Enforcement Actions Relating to Constructed Wetlands at Coburn Pond

Overview:

Figure 1. East Montpelier Coburn Road Wetland Mitigation Site, large. Note VAST trail as built (purple) and as initially proposed (blue). (Coloring, legend, & notes added to Exhibit A).

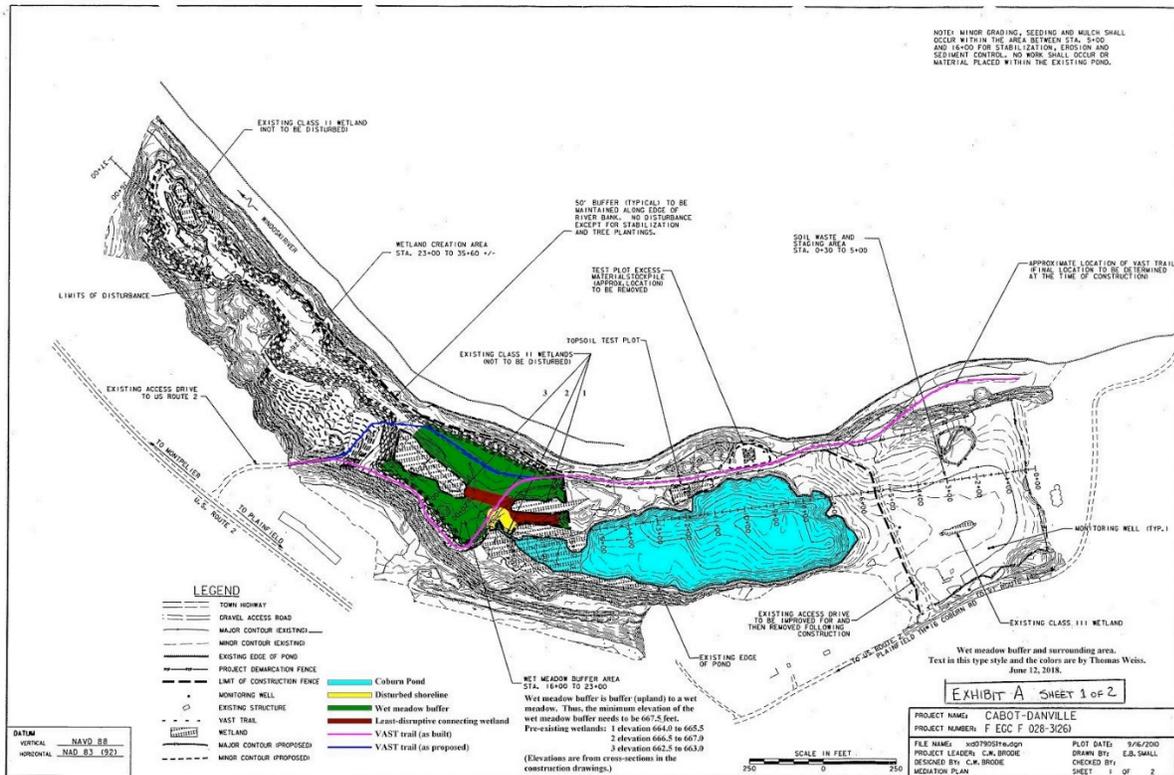
According to Exhibit A of the Settlement Agreement, the “final location” of the snowmobile path was “to be determined at the time of construction.” Exhibit A depicts the proposed snowmobile trail running along the westerly side of the proposed wet meadow buffer, running to the south. However, the VAST snowmobile trail was not built as designed, as shown in Exhibit A. In addition, the Settlement Agreement clearly stated numerous times that the parties Carpenter and Hazel would be notified of any proposed changes before they were made. (Settlement Stipulation 1e, p. 4). The parties were not notified; and as a result of the unplanned change, the trail now goes through the wet meadow buffer constructed at such excessive depth as to hold standing water even throughout most of the coldest winter months. (Figures 1 & 2, based on Exhibit A, show the current location of the trail as marked with posts, as well as the snowmobile trail as initially designed. Figures 3 through 7, and 9, show the trail on February 21, 2018. Figures 10 through 13 show the trail on March 12, 2018. Figures 8 and 14 show the

As it now stands—and especially so during the winter of early 2018—the depth of water across the current snowmobile path, starting no later than late January (even after an extremely cold December), caused the snowmobilers to skirt the water by riding up on the muddied bank of the wet meadow buffer to the north of the standing water. It is not acceptable for the snowmobilers to be compelled to leave the marked trail in order to connect from Coburn Road across to Route 2 because of standing water. VTrans changed their plan, and without consulting with parties as to the proposed change. (These shifts are shown in figures 3 through 5 and 9 through 12.)

Finally, the snowmobile path was not built according to Exhibit A, and without any

discussion or notification to parties. The current snowmobile path crosses the constructed wetlands through the “wet meadow buffer” area, which has standing water throughout much of the winter season. This standing water causes snowmobilers crossing to re-route off the designated snowmobile path onto the banks of the constructed wetland. This cannot be beneficial to newly created wetlands. The snowmobile path as originally planned still has ample snow during most of the winter, when the current path contains standing water. The design change without notification across standing water throughout much of the winter violates the agreement, impedes snowmobile travel connecting Rt. 2 and Coburn Road, and is damaging to the integrity of the constructed wetlands. Remediation should involve moving or reconstructing the trail the trail so it can be used throughout the winter.

Given what we now understand about the excessive standing water throughout the so-called “wet meadow buffer,” and the originally-proposed snow mobile path as identified on Exhibit A, we are seeking remediation through a good faith agreement with VTrans. If VTrans prefers not to build a causeway over the “wet meadow buffer” where the current snowmobile path is currently located, we recommend and suggest, in good faith to all parties, a minor routing change from that initially mapped on Exhibit A.

We suggest that the snowmobile path follow the direction of the original plan from the gate; however, rather than dipping down into the “wet meadow buffer” (that we now know has standing water throughout most of the winter season), we suggest that the snowmobile path run along the dry ridge before dropping down close to the originally-planned wet meadow crossing.
